# Access Compliance Report

## Public Rights-of-Way

### (Curb Ramps)

Intersection ID: 32032	Main Street: COLONY_RD	Cross Street: WAKEHURST_RD	Location: SE
ADA ID: 69EC9EFD576A	Ramp Type: PerpDiag	Initial Pass/Fail: Fail	Overall Compliance: No
Severity Score: 22.5			
Codes/Mitigation Info/Possible Solution		Field Measurements/Component Compliance

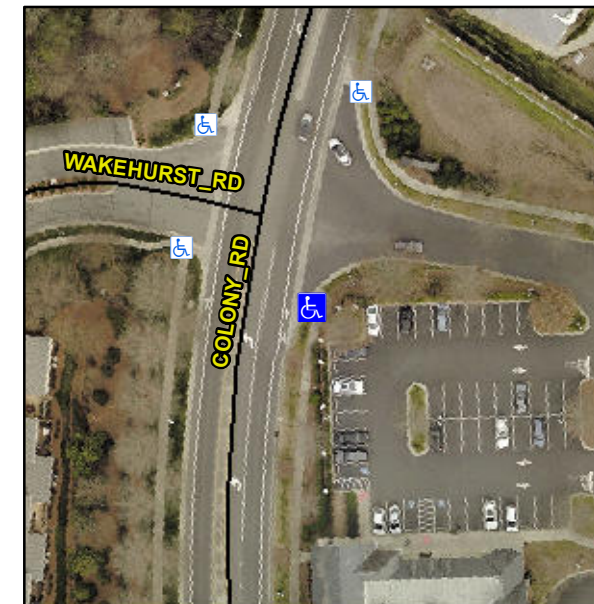
**Not Found, R304.5.1, R304.2.2, R304.5.3**

Compliance	Description	Data	Compliance	Description	Data
N/A	Ramp Length (in)	53.0	No	Ramp Slope (%)	10.5
No	Ramp Width (in)	44.0	No	Ramp XSlope (%)	4.8
N/A	Flare Type LT	N/A	N/A	Flare Type RT	N/A
N/A	Flare Slope LT (%)	N/A	N/A	Flare Slope RT (%)	N/A
N/A	Flare Traversable LT?	N/A	N/A	Flare Traversable RT?	N/A
N/A	Landing Length (in)	N/A	N/A	DWS Provided?	N/A
N/A	Landing Width (in)	N/A	N/A	DWS Contrast?	N/A
N/A	Landing Slope (%)	N/A	N/A	DWS Length (in)	N/A
N/A	Landing X Slope (%)	N/A	N/A	DWS Full Width?	N/A
N/A	Landing Curb? (Y/N)	N/A	N/A	DWS Offset (in)	N/A
N/A	Shared Landing?	N/A			
N/A	Gutter Ponding?	N/A	N/A	Gutter Slope (%)	N/A
N/A	Gutter Lip Ht (in)	N/A	N/A	Gutter X Slope (%)	N/A
N/A	Painted X Walk1?	No	N/A	Painted X Walk2?	No
	X Walk 1 Direction	To NE		X Walk 2 Direction	To NW
N/A	X Walk 1 Width (in)	N/A	N/A	X Walk 2 Width (in)	N/A
	X Walk 1 Slope (%)	1.7		X Walk 2 Slope (%)	1.7
	X Walk 1 X Slope (%)	7.5		X Walk 2 X Slope (%)	0.9

**Remove & Replace Curb Ramp With Two New Directional Ramps or Equivalent.**
